February 21, 2023

**RE: Comments on the U.S. Forest Service Mountain Valley Pipeline and
Equitrans Expansion Project Draft Supplemental Environmental Impact
Statement (#50036)**

Figure 1.

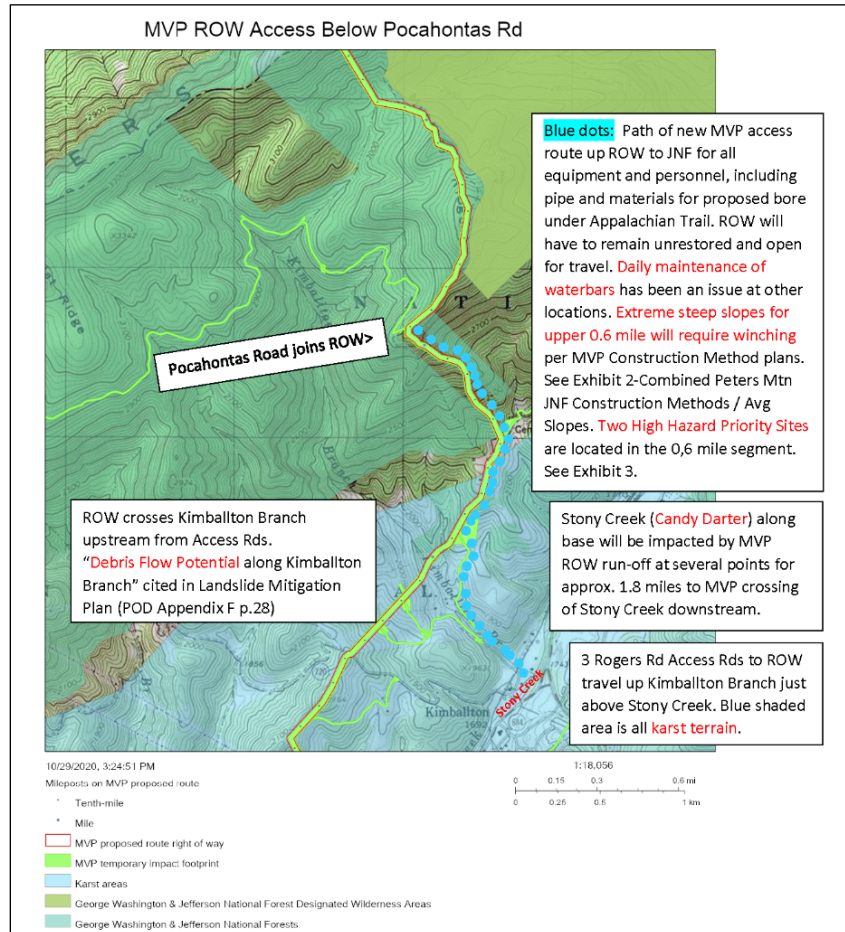
Pipeline construction on Peters Mountain in Virginia will increase sediment and construction pollutants in the candy darter's critical habitat. Kimballton Branch will bear the brunt of MVP's failed ECDs. The impact will extend from its headwater tributaries close to MVP's bore pit at Peters Mountain to Rogers Road before entering Stony Creek (Figure 1).

According to the *Fisheries and Aquatic Resources Specialist Report* prepared for the Forest Service, a mixing zone on private land at the confluence of Kimballton Branch and Stony Creek was predicted to have suspended sediment concentrations above the threshold for adverse impacts.²¹⁸ Actions on NFS lands would contribute to sedimentation and related effects on candy darter habitat in this mixing zone. No analysis of embeddedness has been conducted for the sections of Stony Creek that are directly upstream and downstream of the Kimballton Branch confluence. The Forest Service must ensure this analysis is undertaken.

Figure 6. Virginia’s seismic zones include the Giles County Seismic Zone. The smaller map shows the proposed ANST crossing.

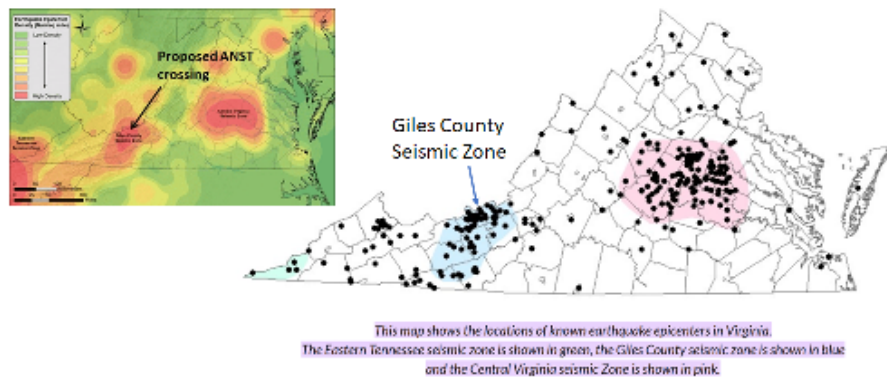
Instead, the DSEIS focuses too narrowly on faults lying within the JNF to the exclusion of nearby earthquakes that could affect the safety of pipeline located in the JNF. In reality, earthquakes from as far away as the Charlottesville area (such as the 2011 “Louisa” earthquake) are felt on Peters Mountain. The High-Hazard study does even not mention the Giles County Seismic Zone (GCSZ) illustrated in Figure 6, even though the proposed JNF crossing lies near the center of the zone and earthquakes in that zone are mapped prominently on the website of the Virginia Department of Energy.²³⁶

In addition, the High-Hazard study failed to discuss seismic activity at all for High-Hazard area #5 (WV side) and dismissed the seismic area as “inactive” near High-Hazard area #3.

The DSEIS has not adequately analyzed the hazards associated with the proposed ANST crossing location. The Forest Service should do so in a revised DSEIS.

Figure 7. The red line in this Google Earth screenshot is the proposed MVP ROW.

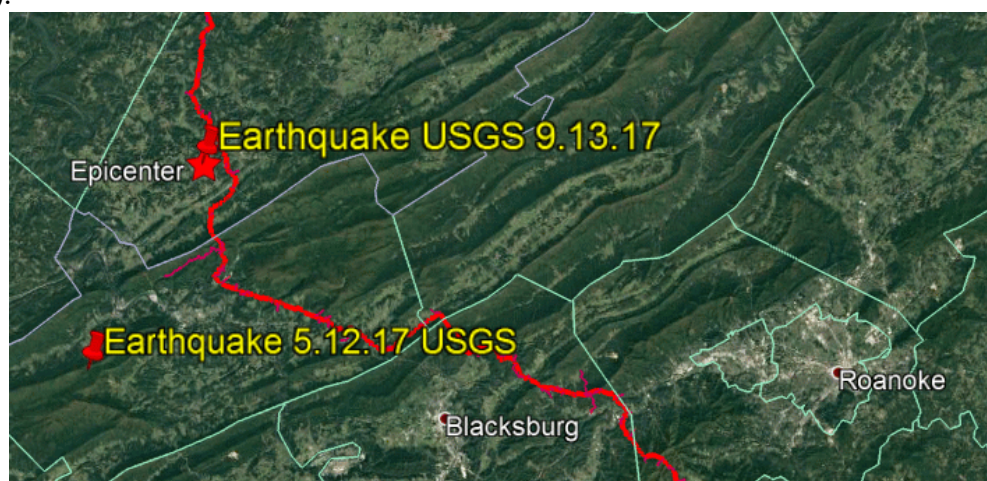
At least three notable earthquakes have occurred within 12 miles of the MVP ROW in the JNF since publication of the High-Hazard study in December 2016:

- On May 12, 2017, a magnitude 2.8 event occurred near Narrows, Virginia, less than 12 miles from the proposed ANST crossing by MVP.²³⁹
- On September 13, 2017, a magnitude 3.2 earthquake occurred—the largest in decades in the Giles County Seismic Zone, with an epicenter less than 2 miles from the MVP ROW in Monroe County, WV and less than 5 miles from the bore pit above High-Hazard area #5 (See Figures 7, 8, 9).²⁴⁰ The *Roanoke Times* reported that more than 200 calls came into the Giles County Sheriff’s Office dispatch in the half hour after this earthquake.²⁴¹ The Virginia Tech Seismological Observatory, which uses slightly different measurement strategies than USGS, rated it a magnitude 3.7 earthquake.
- On September 27, 2021, the USGS reported a magnitude 2.6 earthquake near Brush and Sinking Creek mountains, where High-Hazard areas #2 and #6 are located (See Figure 9).²⁴²

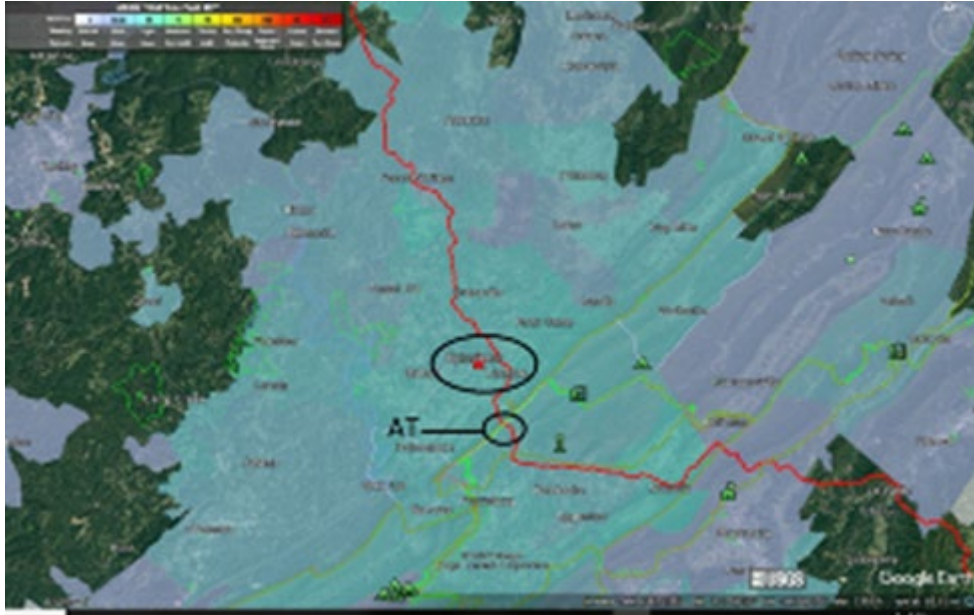
In addition, the Forest Service ignores the extremely widespread impact of the August 23, 2011, “Louisa” earthquake in central Virginia. This magnitude 5.8 earthquake was felt along the entire MVP ROW. The website of the Virginia Department of Energy identifies it as the most damaging earthquake ever felt in Virginia and “the most widely-felt earthquake in U.S. history.” Approximately 150,000 individuals reported feeling the earthquake through the U.S. Geological Survey Earthquake Hazard Program. Its impact extended over the entire eastern United States and into Canada.²⁴³

Figure 11. the area impacted by a magnitude 5.8 earthquake in Virginia compared to a magnitude 6.0 earthquake in California.

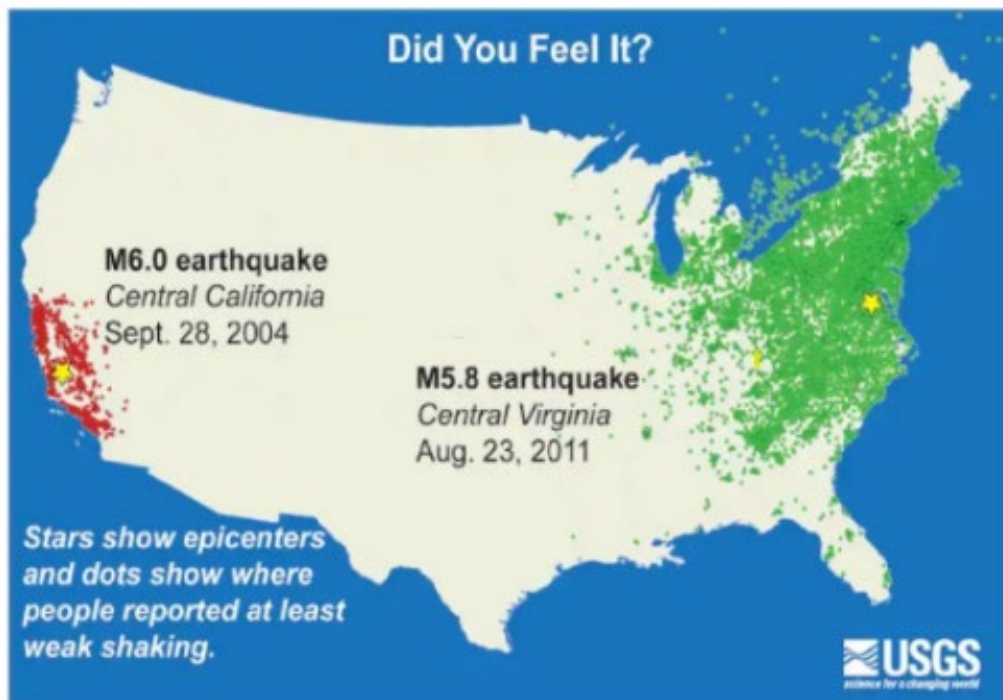
Neither the High-Hazard study nor the current or past USFS permit materials discuss the difference between eastern and western earthquakes. “The earth’s crust is stronger here,” explains Martin Chapman, director of the Virginia Tech Seismological Observatory. “So shock waves moving from the epicenter of an earthquake don’t lose as much energy as during quakes in California. When a magnitude 7.0 earthquake occurs in the Southeast, the waves affect a larger area and can cause more damage at a greater distance than when a similar shock hits

California.”²⁴⁴ Note below in Figure 11 the area impacted by a magnitude 5.8 earthquake in Virginia compared to a magnitude 6.0 earthquake in California.

Figure 13. Visual impacts on the ANST showing how much of the MVP ROW scar could potentially be visible from the ANST. Over 15 miles of the MVP ROW could potentially be seen from Angel's Rest (#1) and from Peters Mountain near Symms Gap (#2), while 1 to 2 miles could be visible from Kelly Knob.

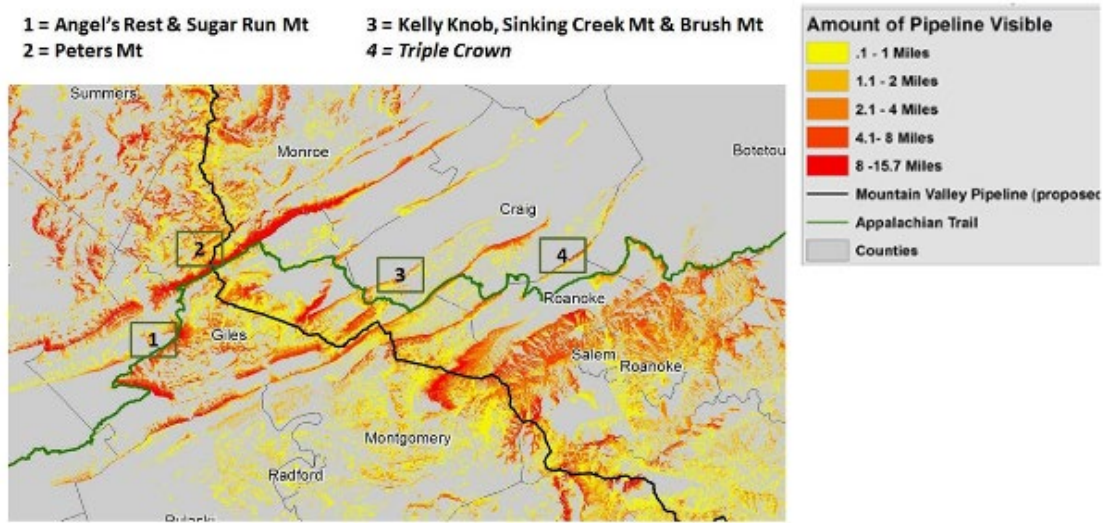
Tetra Tech was instructed by the Forest Service to ignore the visual impacts of the MVP ROW unless the ROW itself was on USFS land. At Symms Gap on the crest of Peters Mountain, for example, where the pipeline ROW would be visible into West Virginia for 15 miles or more, the only photo taken is of the ground, as seen in Figure 12, instead of toward the views of the landscape of West Virginia.²⁴⁷ This completely ignores the actual scenic impact on the ANST and its users.

In its response to Tetra Tech study #1, the RATC shared a map of likely MVP visual impacts on the ANST showing that much of the MVP ROW scar would likely be visible from the ANST, as seen in Figure 12.²⁴⁹

Figure 14: Simulated visual impacts that someone walking on the ANST would see from Angel's Rest. Tetra Tech study #1 called this impact "barely perceptible."

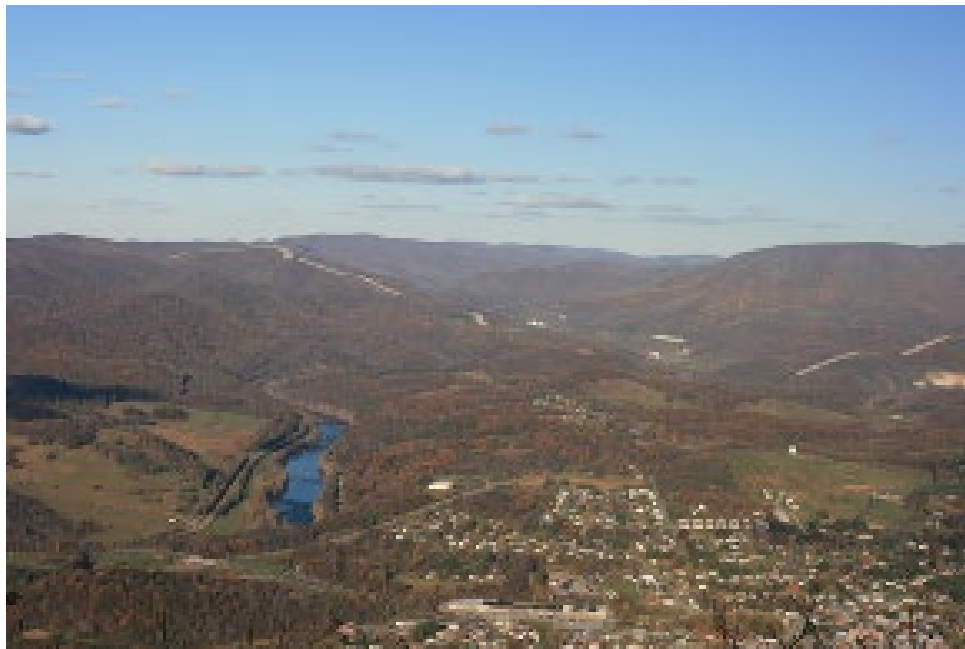
ATC and RATC worked together to produce a list of approximately 15 locations on the ANST that could suffer visual impact from MVP. In addition, RATC filed visual simulations from Angel's Rest and other locations showing the likely actual visual impacts of MVP on the ANST. The simulation for Angel's Rest is shown below in Figure 14.

Figure 18. National Agricultural Imagery Program (NAIP) imagery of pipes exposed to the elements in Jefferson National Forest on the upper (A), mid- (B), and lower southeastern (D) slopes of Sinking Creek Mountain; and on the lower (C) and upper northwestern slopes (E) of Brush Mountain. 10/18/2018.

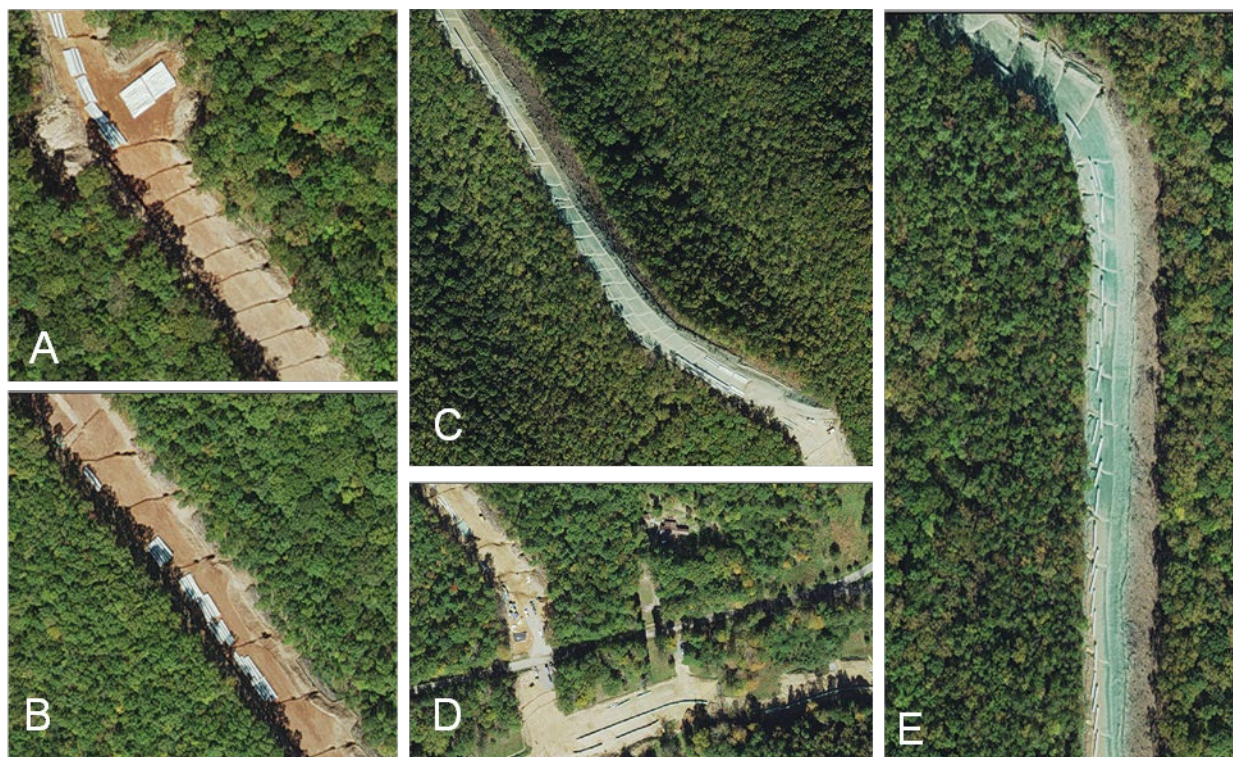
It is clear that the pipes stored above ground within the JNF have been subjected to accelerated corrosion.²⁹⁰ The pipe ends are open such that rain, snow, and atmospheric moisture are able to enter the uncoated interiors and thus to cause corrosion of the uncoated interior steel. Mountain Valley has stored additional pipes off-site, apparently intending them for installation within the JNF (Figure 23). The storage conditions and weathering status of those pipes and their coating is of concern as well.

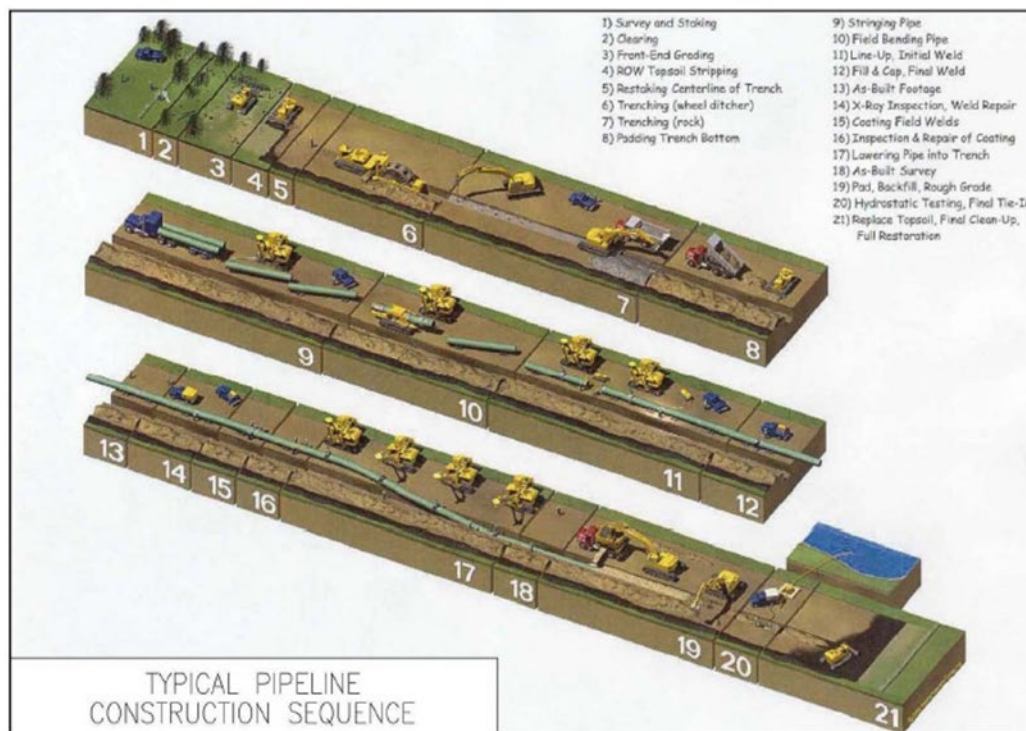
Figure 24. Excerpt from Mountain Valley Pipeline’s application to the Federal Energy Regulatory Commission, Resource Report 1, October 2015.³⁰² The typical pipeline construction sequence, as represented, demonstrates that pipes are subject to flexing during installation. The upper-right legend designates operation 9 as “Field Bending”. Pipes are welded together into long strings above ground (operations 10 and 11). Then, the entire string is moved into the ditch sequentially (Operations 13 through 17). As represented in the drawing at Operation 17, Lowering Pipe into Trench, the pipe string is subject to flexing during the lowering operation. As represented by Figure 2 above, actual pipe strings already assembled but not yet installed on the southeastern slope of Brush Mountain within the JNF are longer than is represented by Mountain Valley’s drawing.

Figure 25.

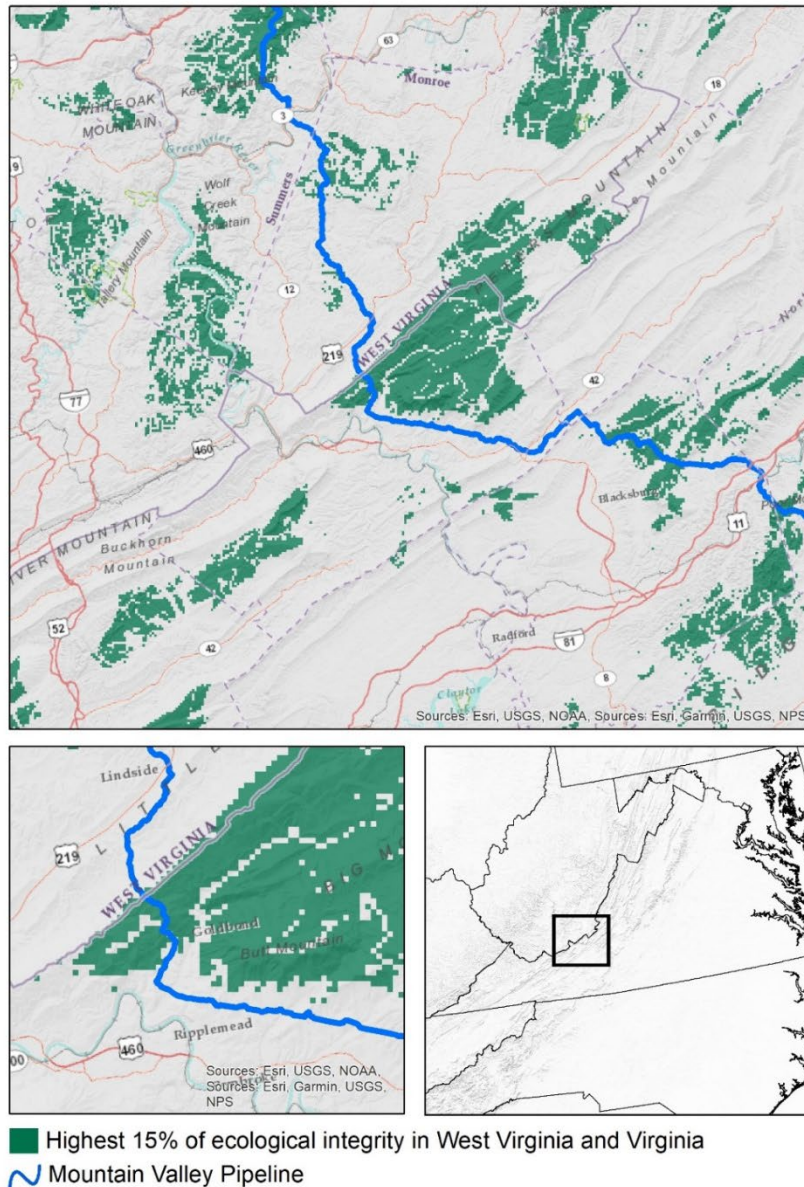
Second, the best available scientific information reveals that MVP will cut across one of the largest blocks of land of high ecological integrity in West Virginia and Virginia. In the past decade, scientists have developed an ecological integrity model using human-modification data.⁶⁹⁹ Data from these studies were applied to West Virginia and Virginia to identify the lands with the 15% highest of ecological integrity. The results (Figure 25) show that MVP intersects one of the top 1% largest high-ecological-integrity areas in the two-state region. That suggests

that MVP may have an outsized impact on ecological integrity in the plan area—if not the region. Since the Forest Service did not perform ecological integrity assessments, conclusions that ecological integrity will be maintained or restored—a high bar when affecting exceptional ecosystems—are arbitrary and capricious under NFMA⁷⁰⁰ and NEPA.⁷⁰¹

Figure 26. This illustrates the Celanese/Columbia pipeline route that crosses the ANST on private land and the opportunity for MVP colocation vs. the proposed MVP route that would cross the ANST on public wildlands in the JNF.

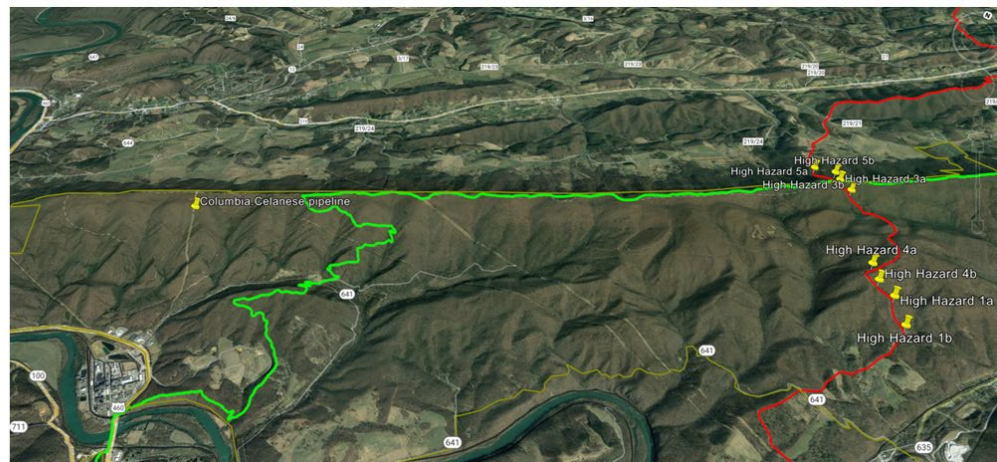
BRIGHT GREEN LINE =
Appalachian National Scenic
Trail. Co-location with
Celanese/Columbia pipeline
would allow ANST crossing in
urbanized area with no scenic
viewpoints.

LARGE RED LINE = MVP ROW,
with ANST crossing at scenic
Symms Gap near two High-
Hazard areas.
